Maxtor Corporation
500 McCarthy Boulevard
Milpitas, CA 95035 USA

To: T10 SAS Protocol Working Group
Contact: Mark Evans
Phone: 408-894-5310
Email: mark_evans@maxtor.com
Date: 13 September 2004

Subject: SAS-1.1, ST_I (transport layer for SSP initiator ports) state machines

Figure 1 — ST_I (transport layer for SSP initiator ports) state machines

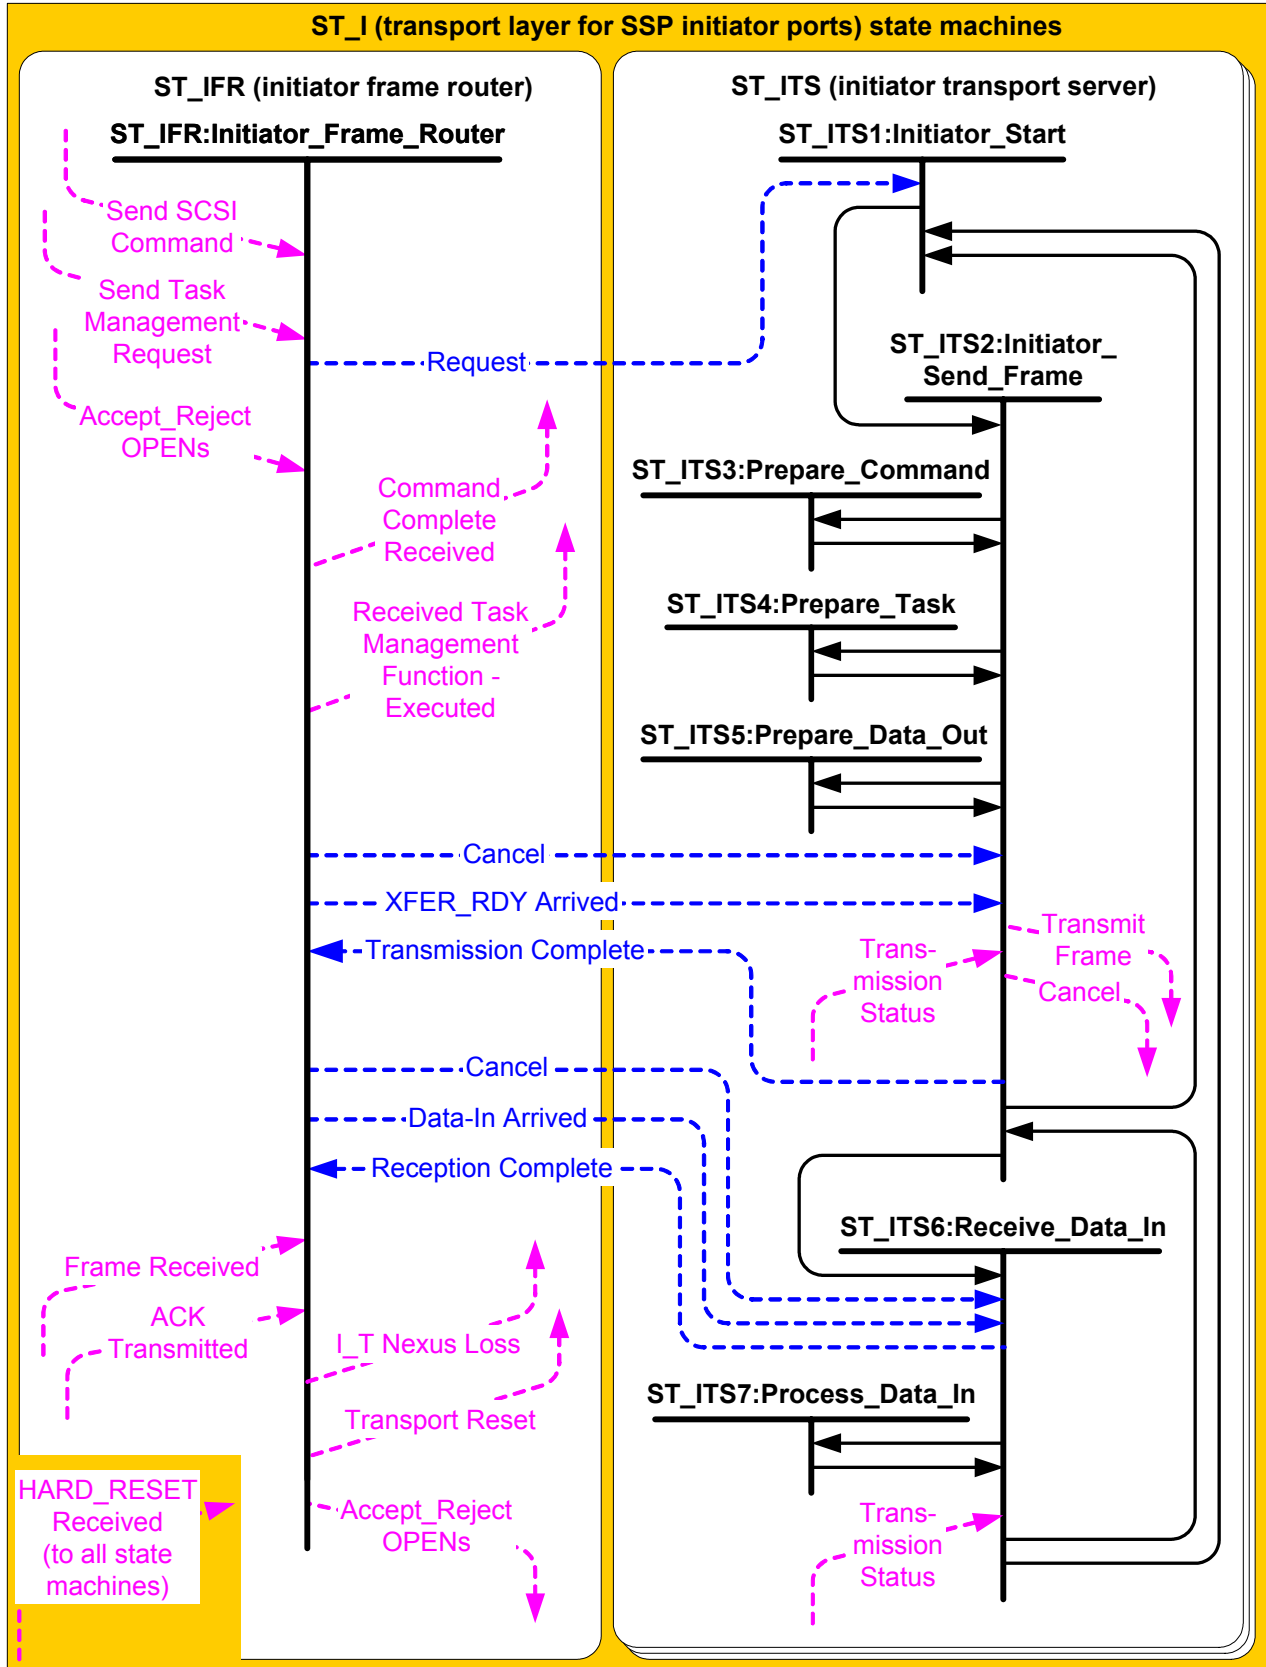
This proposal evolved from adding transport layer retries and the new protocol service, Terminate Data Transfer, to the SSP transport layer state machines. While including these elements, changes were made to simplify and clarify the description of these state machines. These changes include having all communication with the initiator's SCSI application layer be processed by the initiator frame router state machine, having a virtual initiator transport server state machine for each tag, and having the initiator transport server state machines be persistent between power cycles.

Having all communication with the SCSI application layer be processed by the initiator frame router state machine provides the ability for that state machine to maintain context for all tasks in process so that it can abort tasks as necessary. Having initiator transport servers for each tag provides the ability for one state machine to maintain context to process all elements of a task (e.g., COMMAND frame transmission, XFER_RDY reception, and data transfer). Having the initiator transport server state machines be persistent between power cycles simplified their description.

Figure 1 shows the ST_I state machines.
